Product Change Notice (PCN)

PCN Number: PCN-0450726R-03

Product(s) Affected: PJ-002AH-SMT-TR & PJ-002BH-SMT-TR

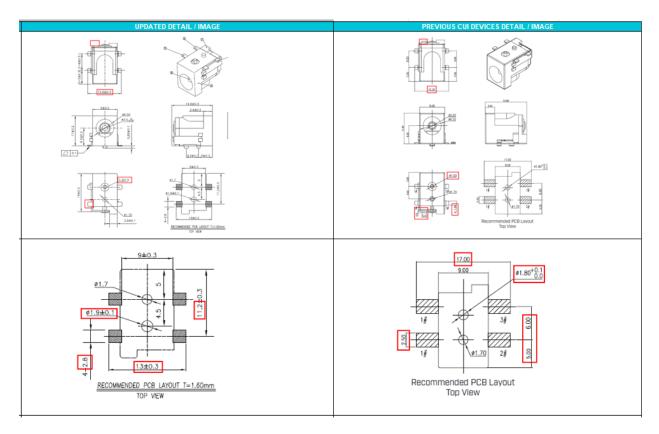
- 1. Overall terminal width is wider. Rectangular feature is not present on updated version. Locating post change to oblong feature.
- 2. Insertion depth change: from 9.5mm to 8.9mm
